State of Illinois  
Illinois Department of Transportation

Addendum  
MANUAL FOR FABRICATION OF PRECAST PRESTRESSED CONCRETE PRODUCTS

Effective: March 25, 2019

Section 3.6.3

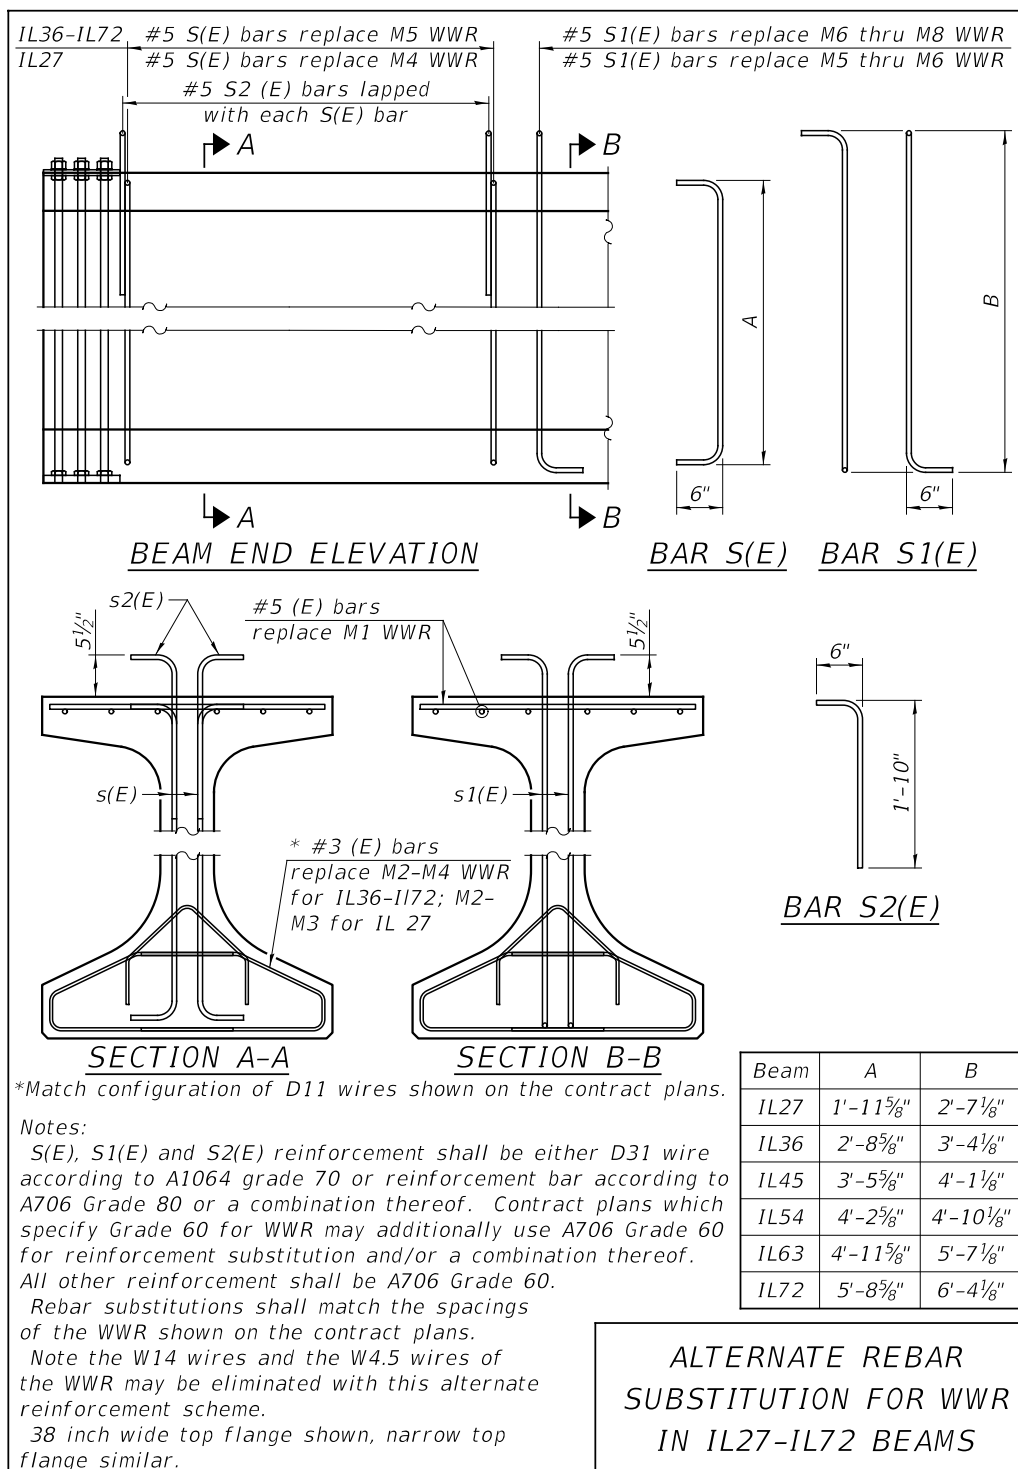
Replace the 3<sup>rd</sup> and 4<sup>th</sup> sentences of the numbered list (as previously amended effective 04/13/18) with the following:

3. Precast prestressed concrete I-beams, Bulb T-beams, and IL-beams used for single-span bridges greater than 100 feet long – the 31<sup>st</sup> calendar day.
4. Precast prestressed concrete I-beams, Bulb T-beams, and IL-beams used for multi-span bridges – the 31<sup>st</sup> calendar day.

**"Alternate Rebar Substitution for WWR in IL27 – IL72 Beams"**

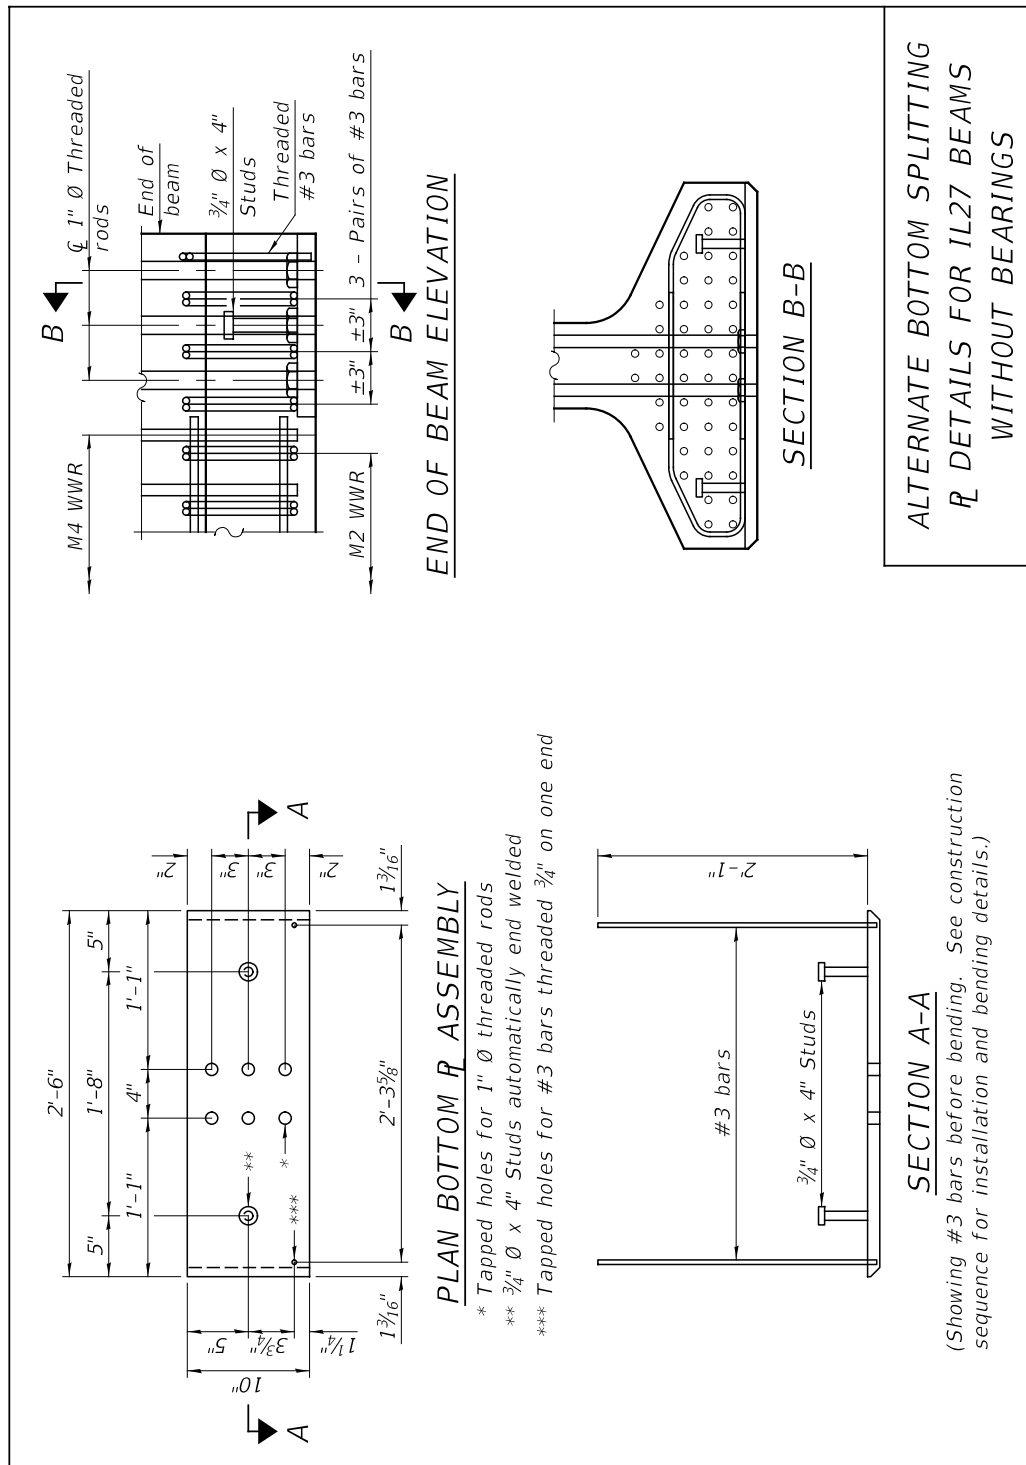
New 1-page detail,

**"Alternate Bottom Splitting Plate Details for IL27 Beams Without Bearings"**

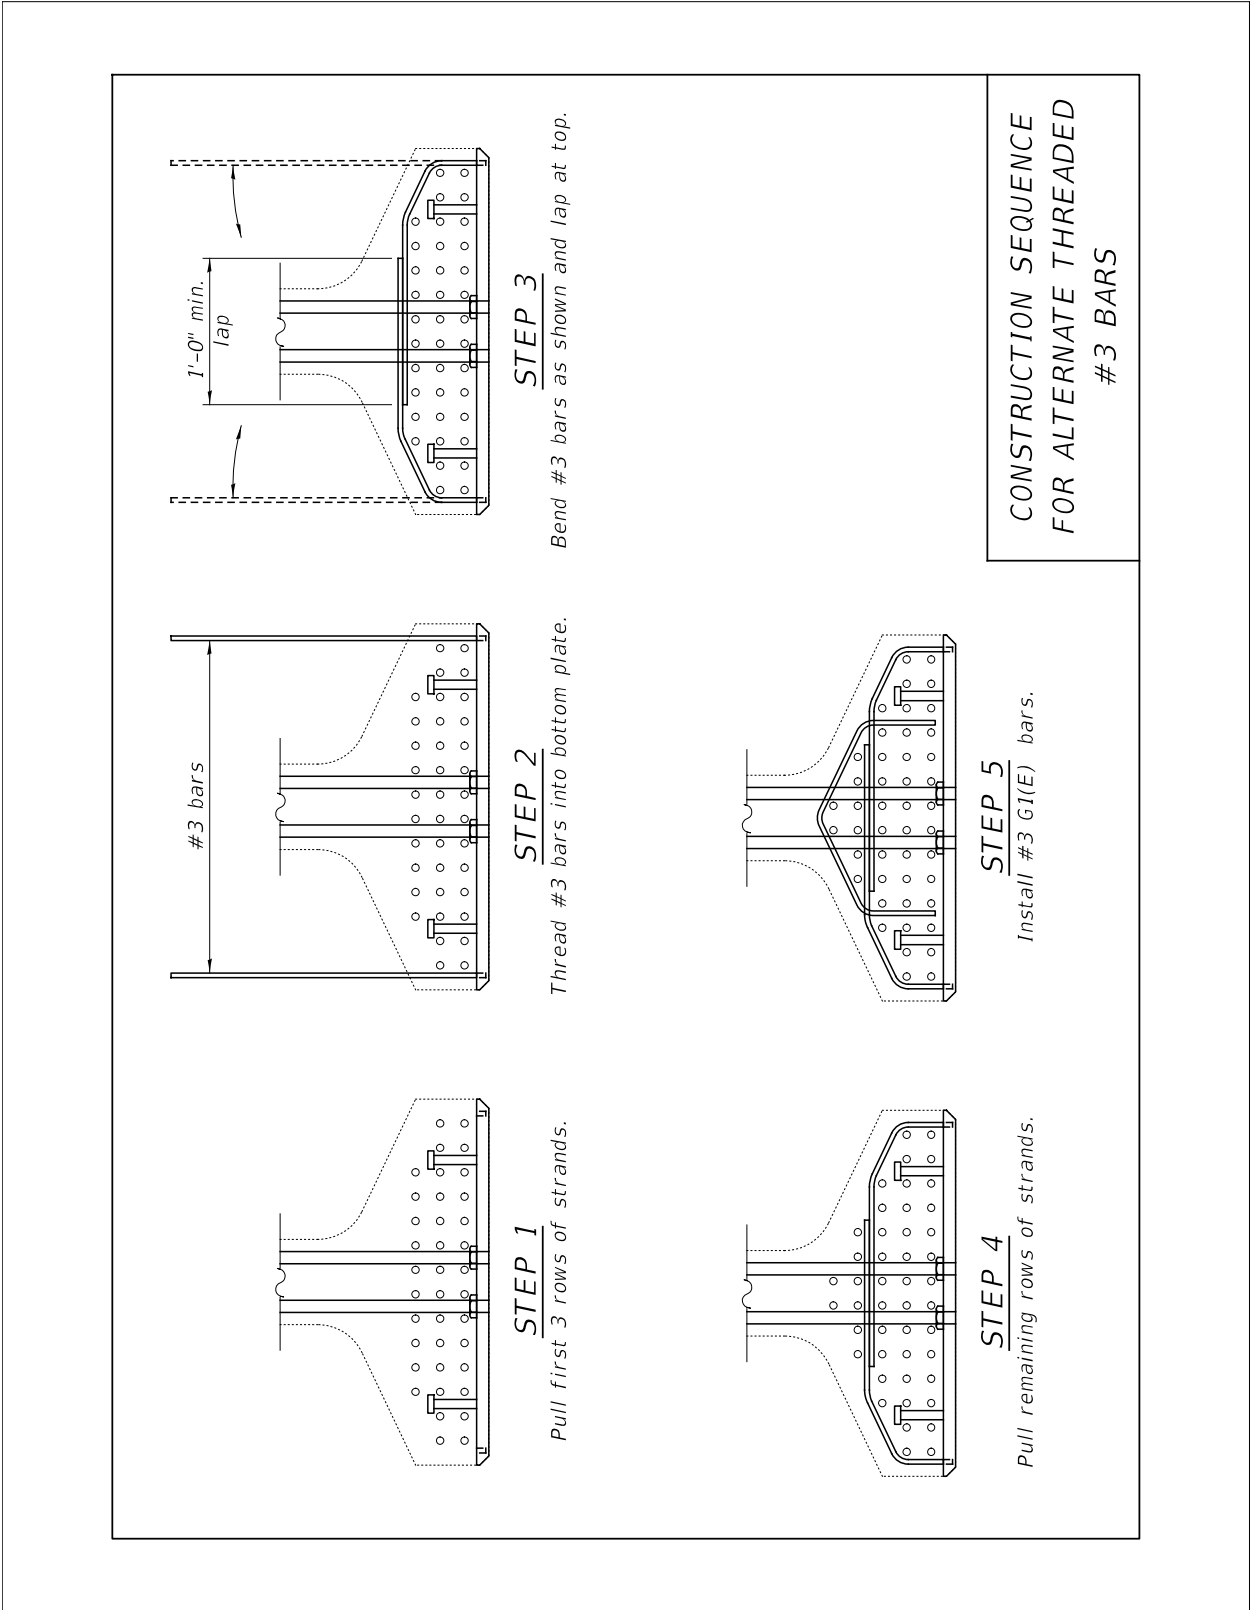
New 3-page detail for IL27 Beams (page 1 of 3)

### “Alternate Bottom Splitting Plate Details for IL27 Beams With Bearings”

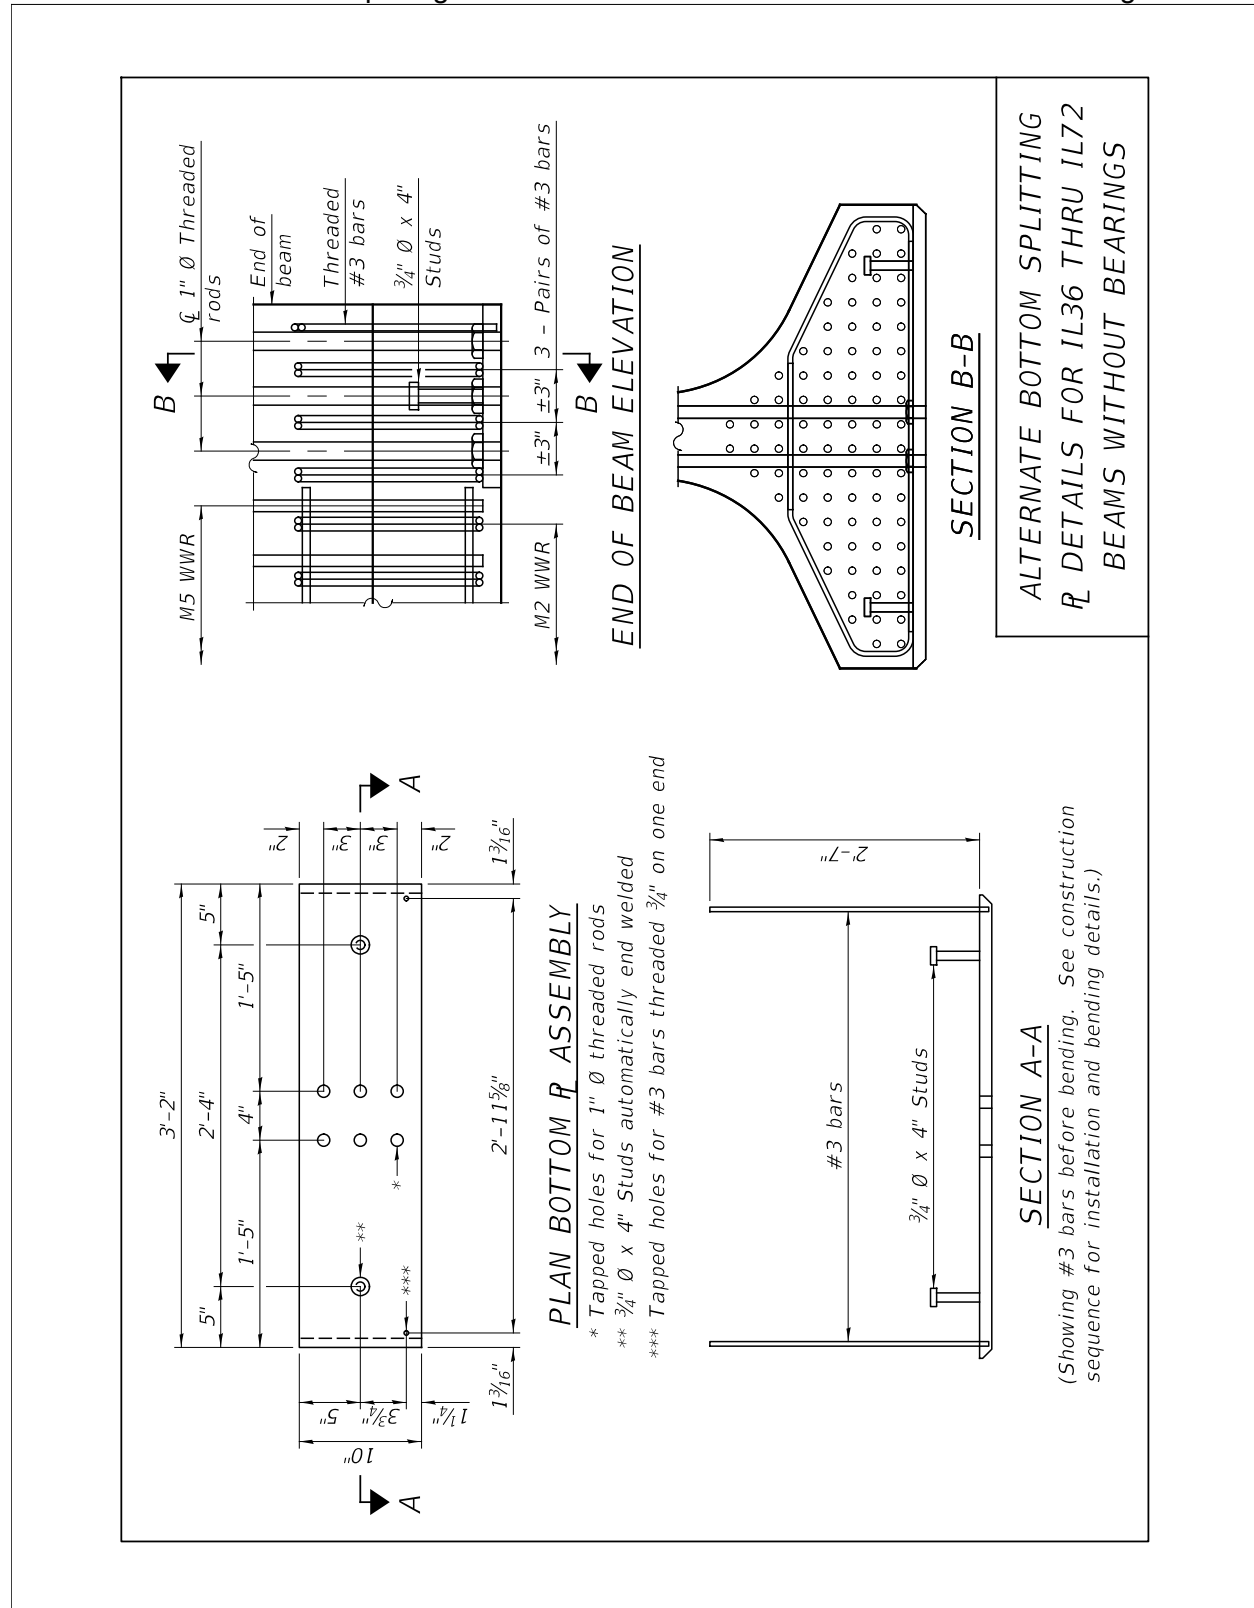
- Add new 1-page detail, “Alternate Rebar Substitution for WWR in IL27 – IL72 Beams”
- Add new 3-page detail for IL27 Beams,
  - “Alternate Bottom Splitting Plate Details for IL27 Beams Without Bearings”
  - “Alternate Bottom Splitting Plate Details for IL27 Beams With Bearings”
  - “Construction Sequence for Alternate Threaded #3 Bars”
- Add new 3-page detail for IL36 – IL72 Beams,
  - “Alternate Bottom Splitting Plate Details for IL36 – IL72 Beams Without Bearings”
  - “Alternate Bottom Splitting Plate Details for IL36 – IL72 Beams With Bearings”
  - “Construction Sequence for Alternate Threaded #3 Bars”
